Technical Information

Beater Shaft Design Change

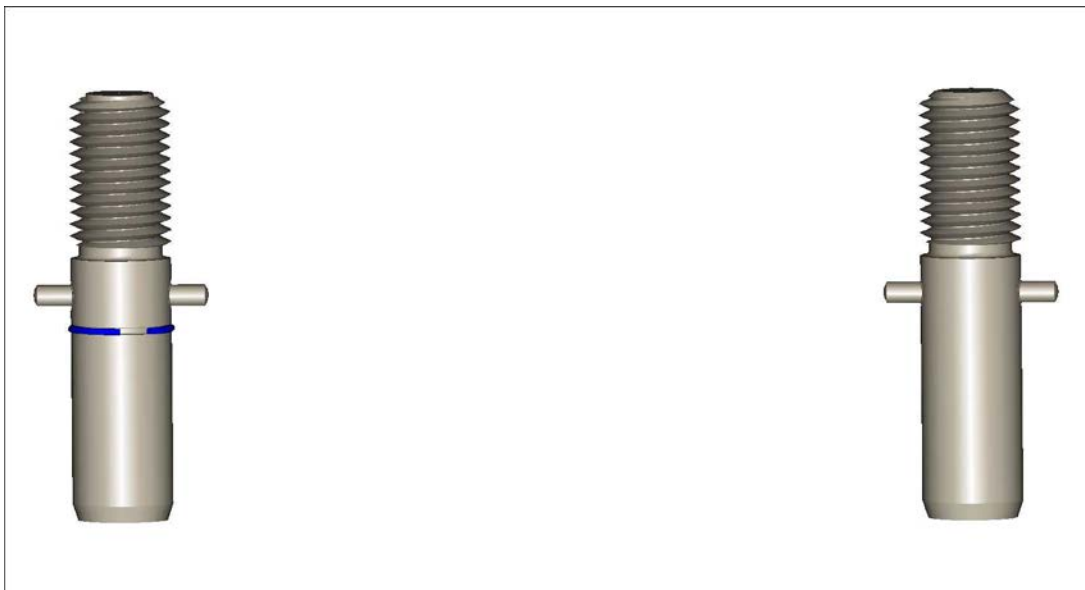
The introduction of more powerful motors and stronger gearboxes on Kenwood kitchen machines (Chef and Major) necessitated a change to the tool shaft and gearbox planet hub, from the original circlip design to a new bayonet type. Cooking Chefs have all been produced from the outset with the bayonet design planet hub.

The change from circlip design to bayonet design was progressively implemented through 2008 production, and all new kitchen machines produced now use the new bayonet design.

New improved circlip shafts were also introduced as part of this engineering change to support previous models. These new circlip shafts have a shorter thread length and shoulder that prevents the shaft nut “winding up” and locking the mixing tool onto the planet hub under heavy mixing loads.

Planetengetriebe ohne Bajonettverschl.

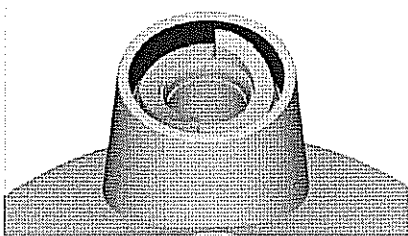
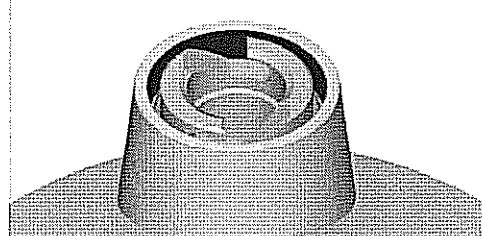
(Bajonettverschluss hat Ähnlichkeit mit einer Lampenfassung)

alter Schaft (nicht für Bajonettverschl.)

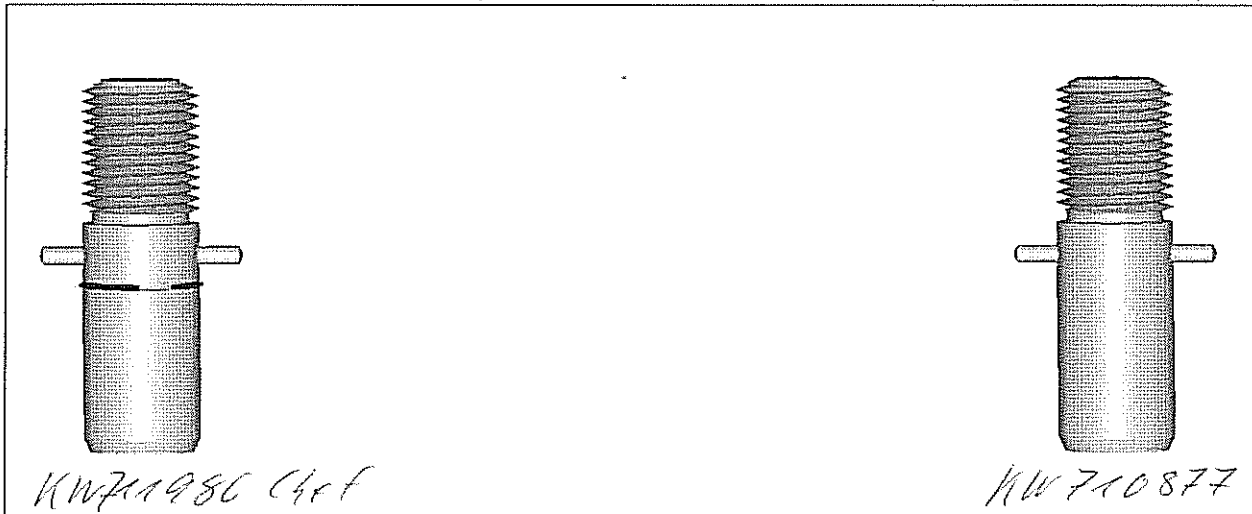
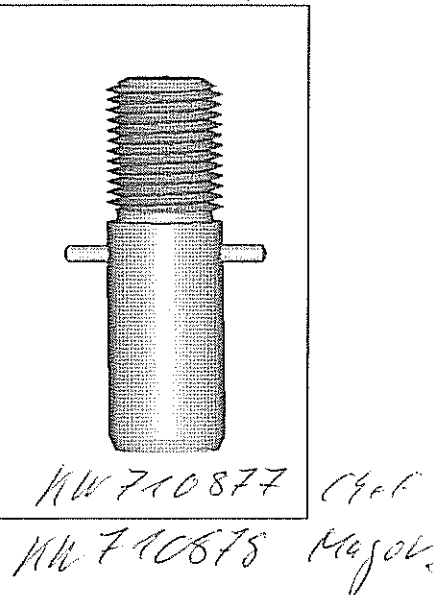
KW711986 Chef
KW711987 Major

KW710877 Chef
KW710878 Major
